MSOX4054A-04-S

Safety Service Note

MSOX4054A Mixed Signal Oscilloscope: 500 MHz, 4 Analog Channels Plus 16 Digital Channels

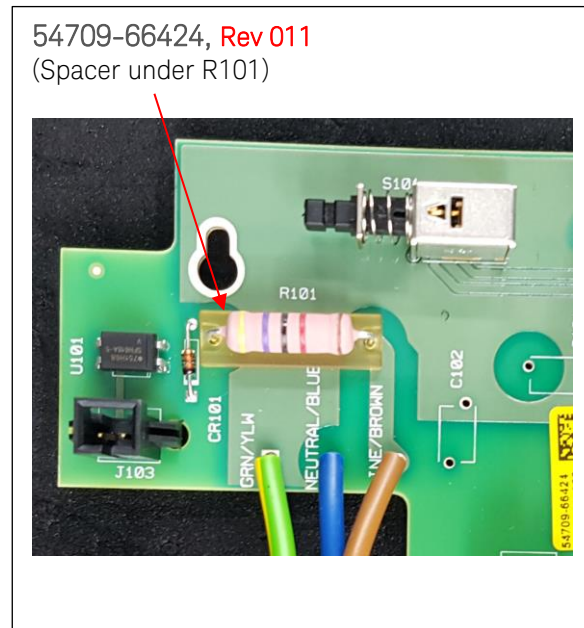
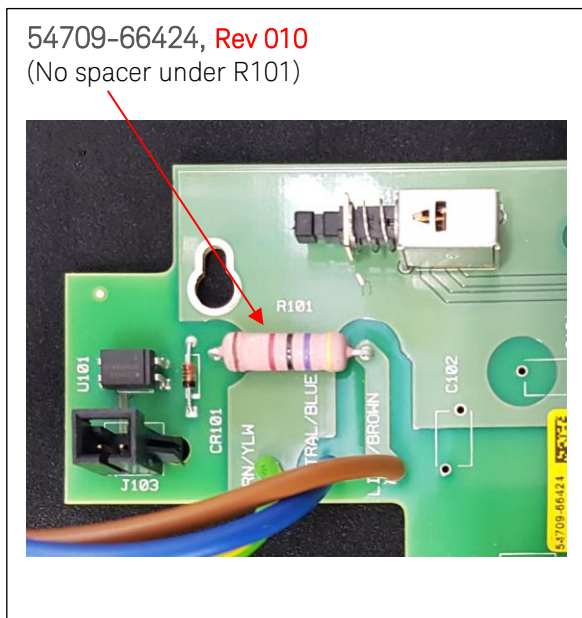
Over the past month, Keysight observed failures during the Routine Safety Test. Investigation found a recently changed R101 resistor, from a 39K ohm part to a new 47K ohm part is against the printed circuit board ground plane and insulation breakdown may cause a safety concern. This issue is limited to the serial numbers listed above.

While the oscilloscope has technically passed all testing and meets product specifications, in an abundance of caution Keysight is recalling and repairing these specific oscilloscopes to ensure the oscilloscope meets the specifications required for Basic insulation by the IEC/UL/CSA 61010-1 standard.

Keysight addressed the issue by placing a spacer under the R101 resistor and updated the 54709-66424 line filter board from rev 010 to rev 011 to reflect the change. The rework on the oscilloscope, performed by a Keysight Service Center, replaces the rev 010 line filter board (54709-66424) with the rev 011 line filter board as specified in the Keysight InfiniiVision 4000 X-Series Oscilloscope Service Guide.

- Perform HiPot.
- Replace the 54709-66424, rev 010 line filter board with 54709-66424, version 011 line filter board as specified in the Keysight InfiniiVision 4000 X-Series Oscilloscope Service Guide. The difference between the two revisions is that rev 011 has a spacer under the 47K resistor.
- Perform HiPot test
- Perform Hardware Self Test: Utility (key) → Service (softkey) → Hardware Self Test (softkey)
- Do Performance Verification (PV) as specified in the Keysight InfiniiVision 4000 X-Series Oscilloscope Service Guide
 - If PV fails, perform User Calibration redo PV
